ZONING CONDITIONS FOR THE MERRITT RESERVE

CONSTRUCTION DRAWINGS FOR MERRITT RESERVE

PROJECT NUMBER = CID-25-XX

JOB NUMBER: 23-0004
 CHECKED BY: BH
 DRAWN BY: DH/RC/SM/GE/MA/LL/JB
 DATE: 04/14/2025
 SHEET TITLE:
CU-202 PLAN & PROFILE
 SHEET NO.: ---

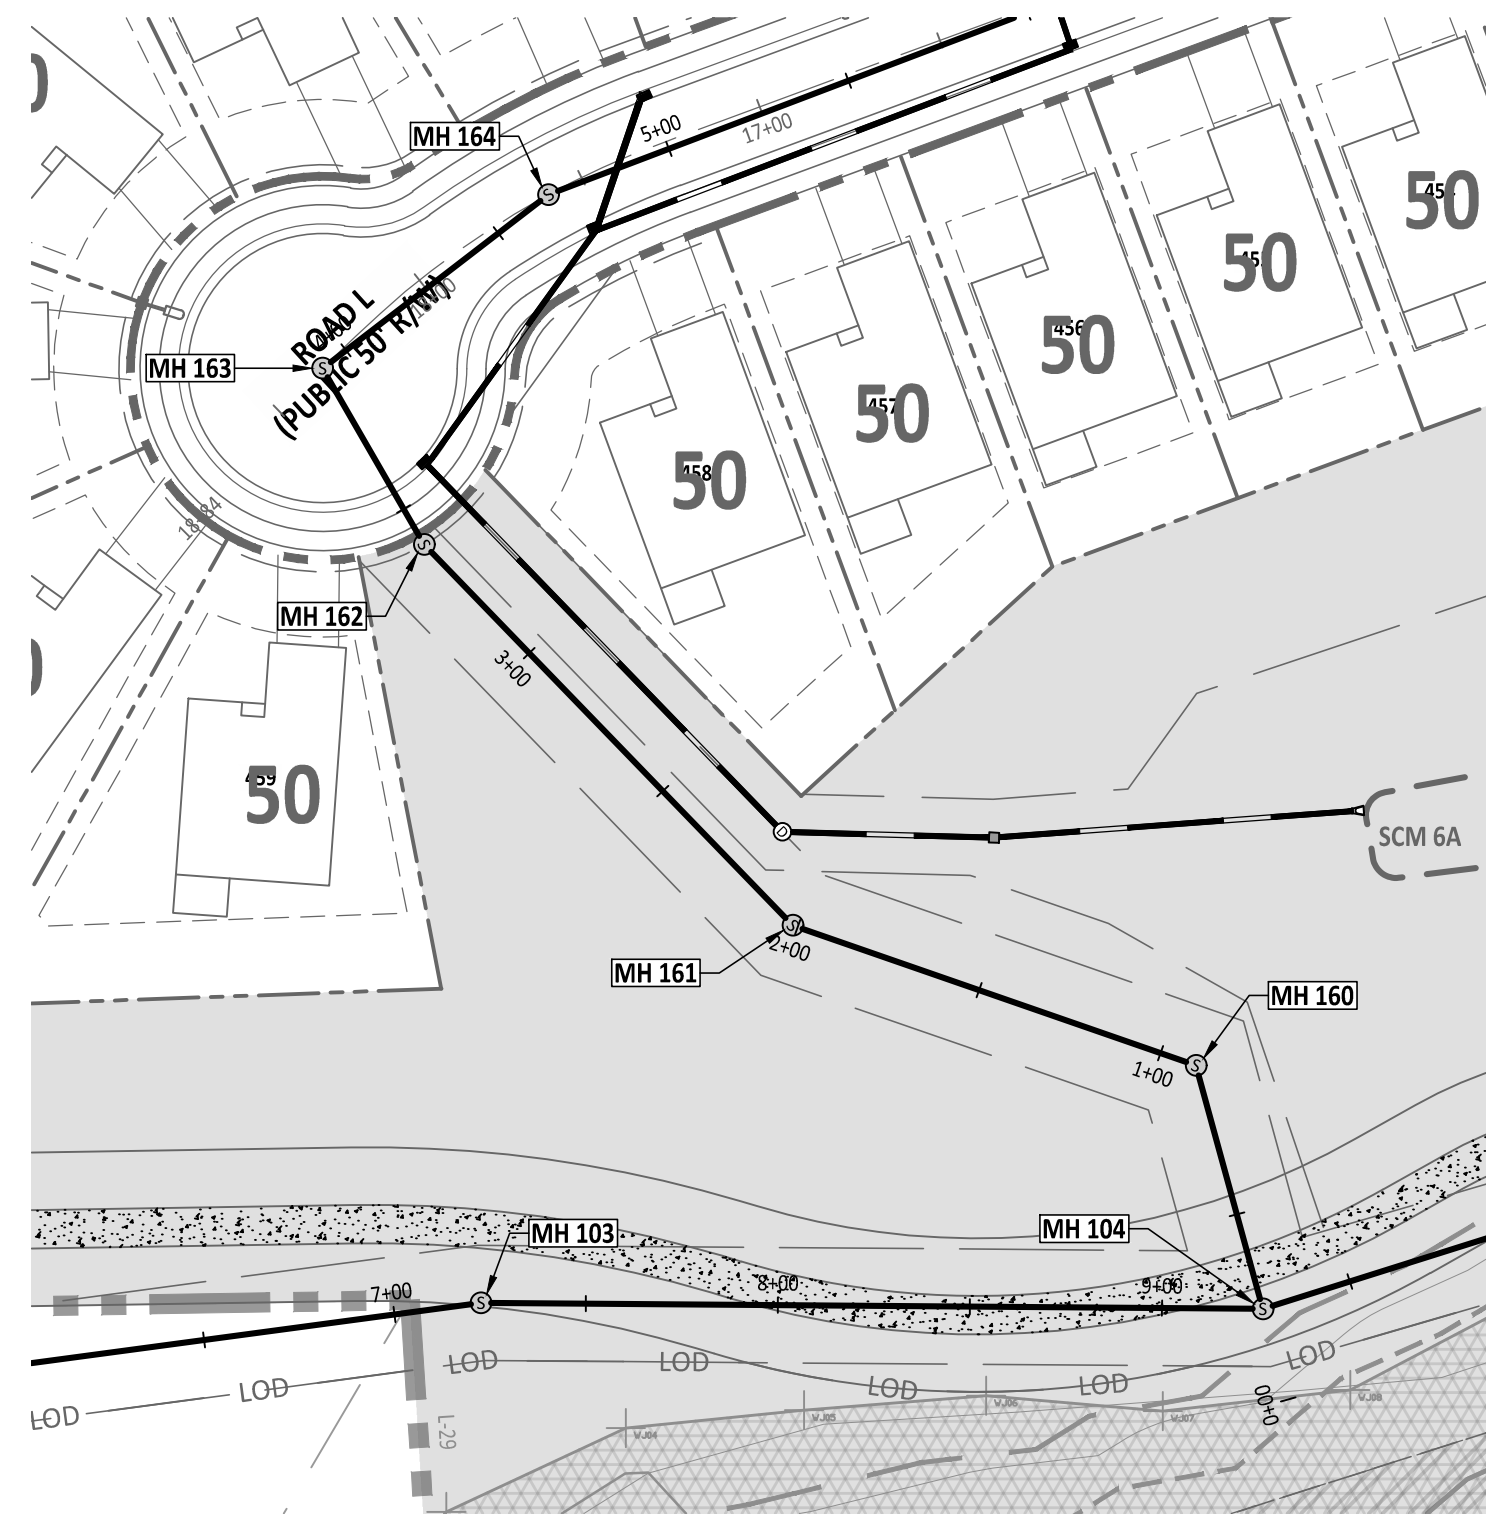
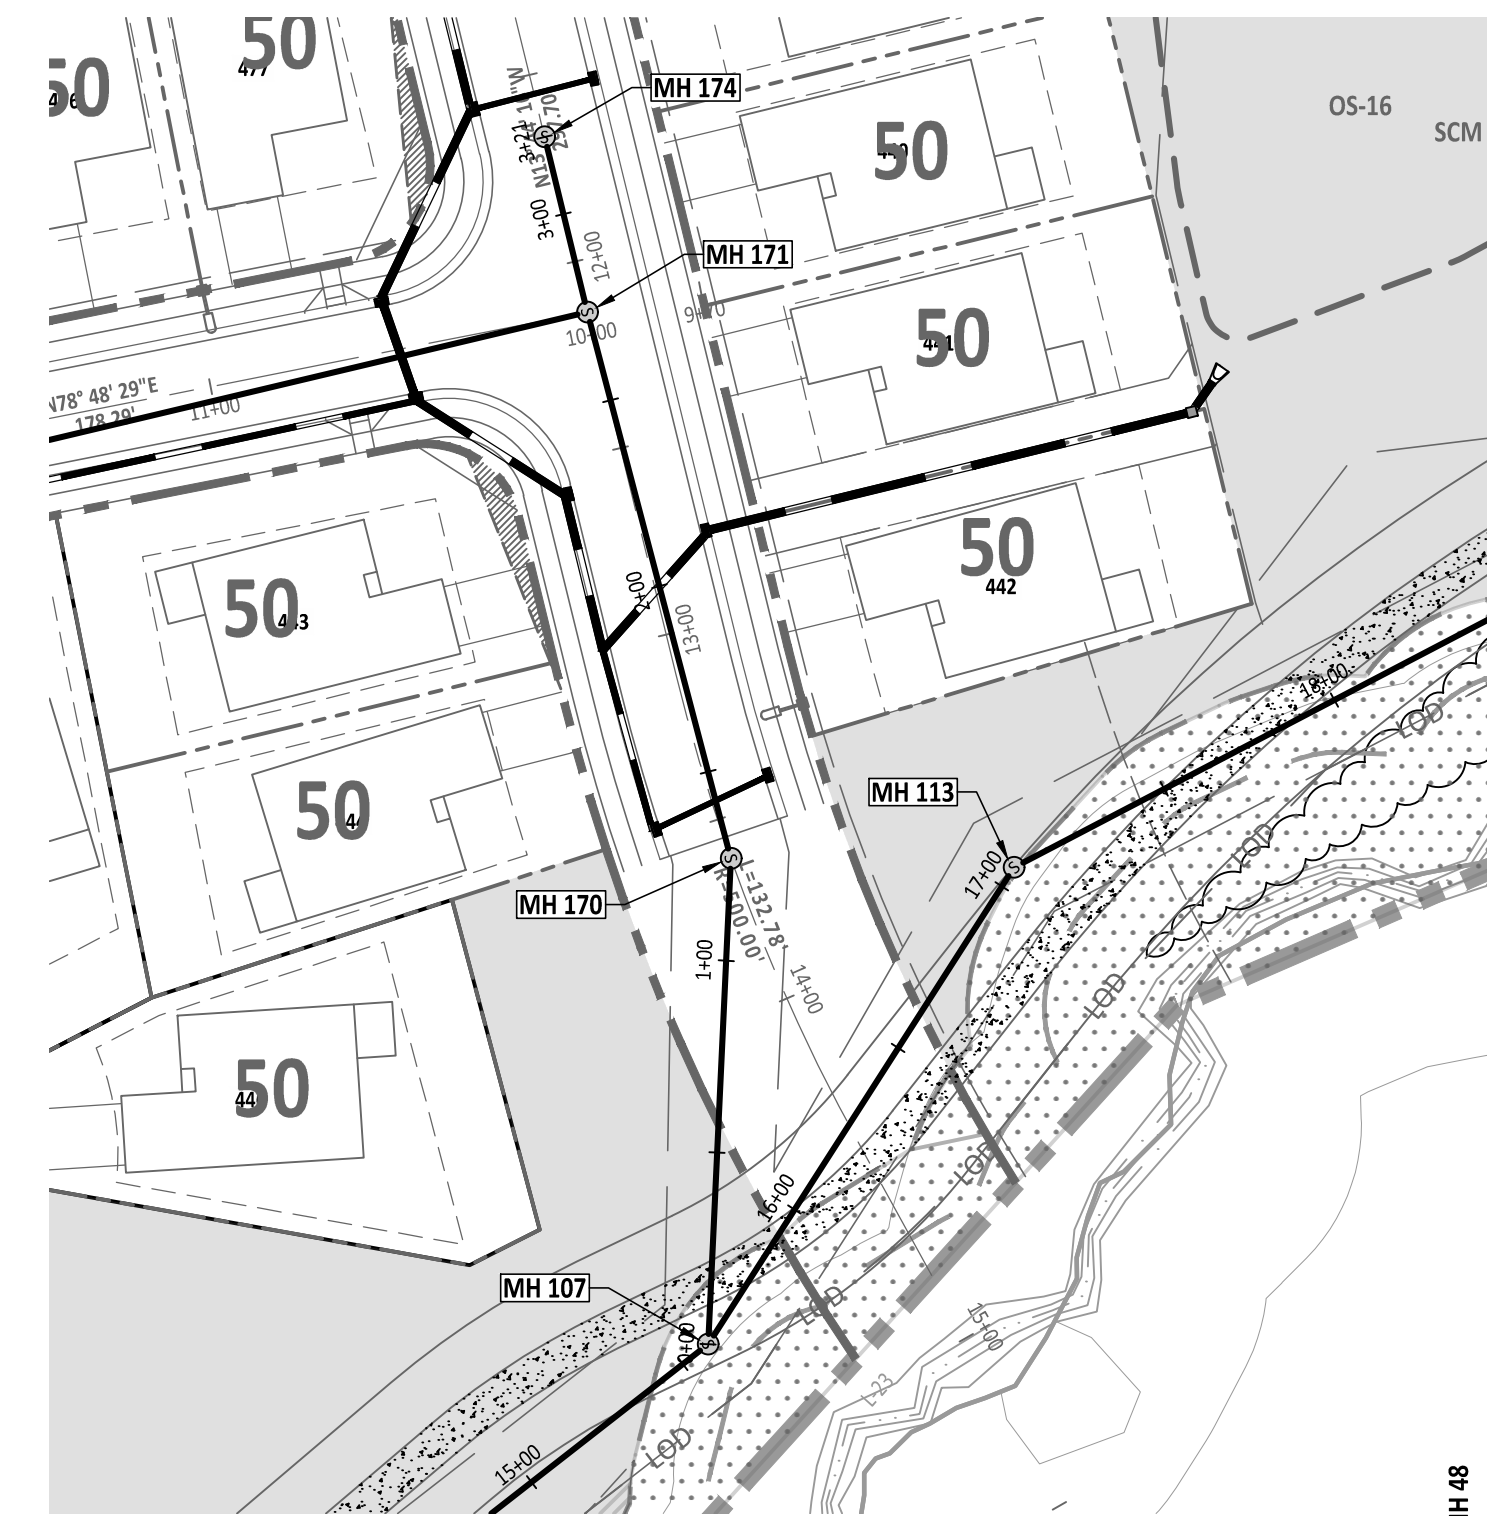
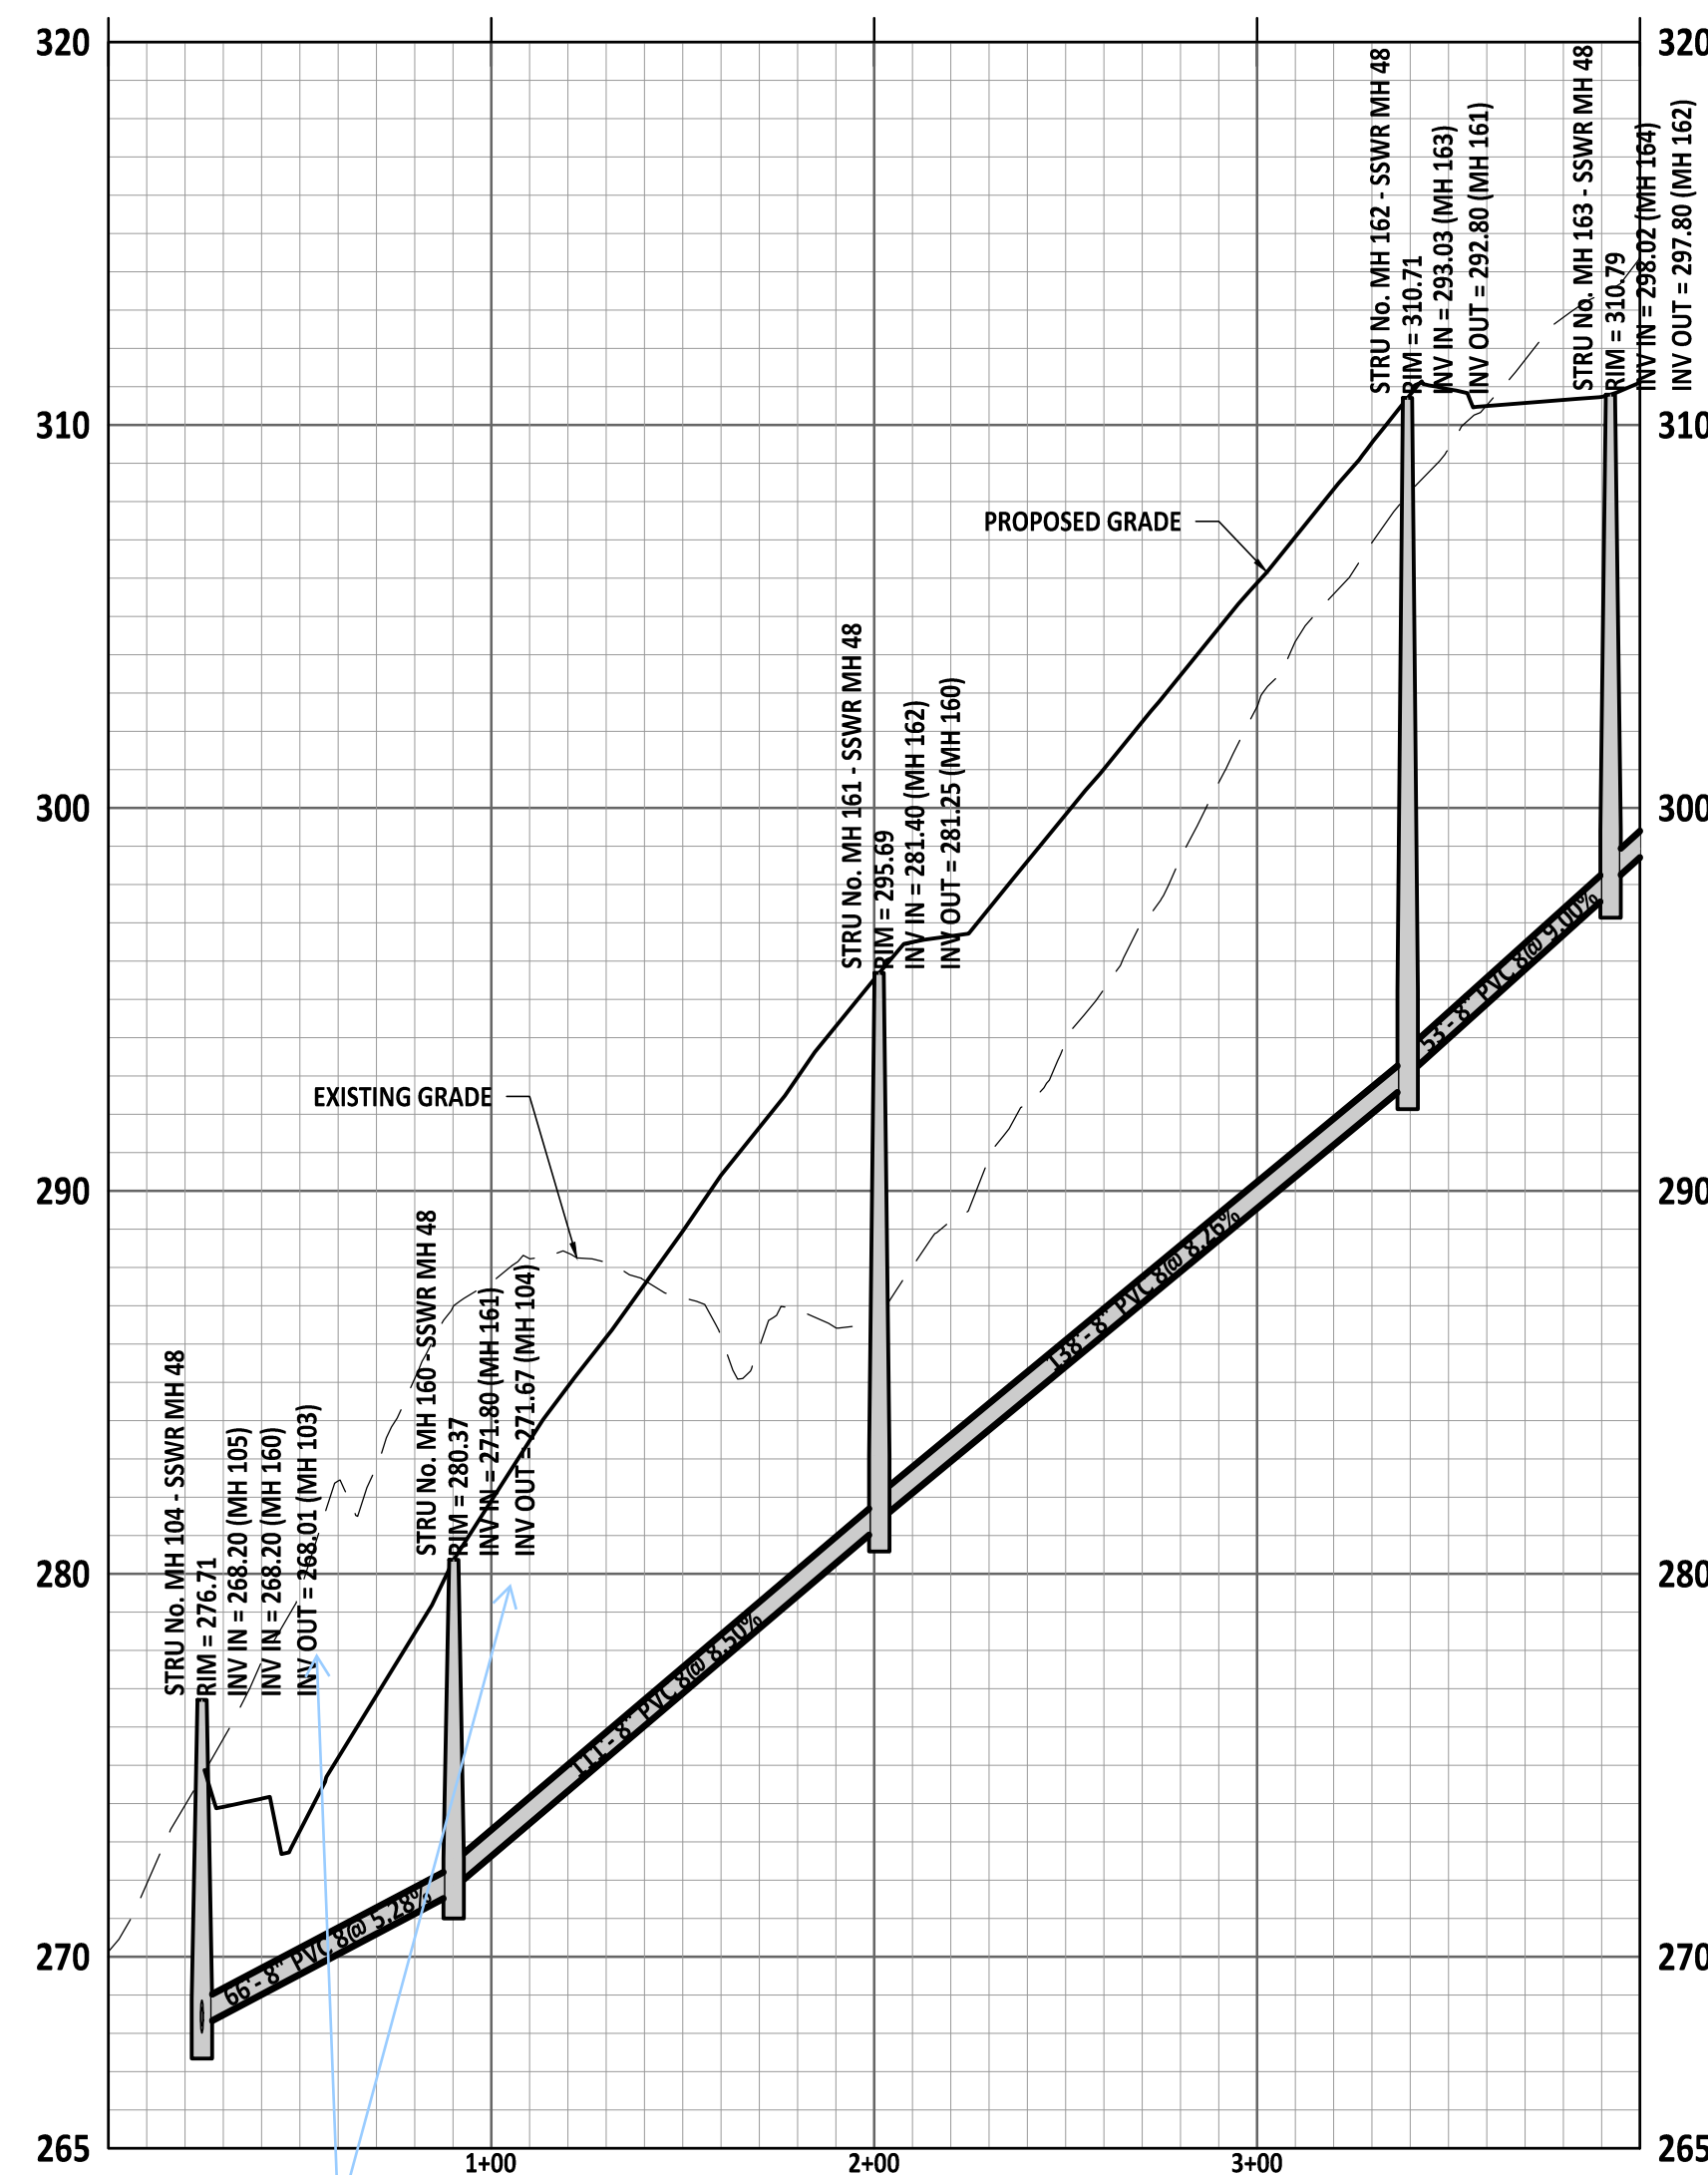
SDR 26 PVC if installation depth exceeds 12'.

Please provide 2/10 drop between inverts. THIS HAS BEEN CORRECTED

This sewer is uncomfortably deep for installation within a roadway...this will be greatly problematic for future maintenance. You'll need to demonstrate that no other design alternatives for sewer installation are feasible for Raleigh to allow this...

THIS WILL BE CORRECTED SEPARATELY. WE ARE CURRENTLY GOING THROUGH POSSIBLE LAYOUT CHANGES TO REDUCE COST OF THE PROJECT. THE MATERIAL AND MANHOLE SIZES WILL BE UPDATED WHEN SEWER DESIGN IS FINALIZED.

THIS WILL BE CORRECTED SEPARATELY. WE ARE CURRENTLY GOING THROUGH POSSIBLE LAYOUT CHANGES TO REDUCE COST OF THE PROJECT. THE MATERIAL AND MANHOLE SIZES WILL BE UPDATED WHEN SEWER DESIGN IS FINALIZED.

THIS WILL BE CORRECTED SEPARATELY. WE ARE CURRENTLY GOING THROUGH POSSIBLE LAYOUT CHANGES TO REDUCE COST OF THE PROJECT. THE MATERIAL AND MANHOLE SIZES WILL BE UPDATED WHEN SEWER DESIGN IS FINALIZED.
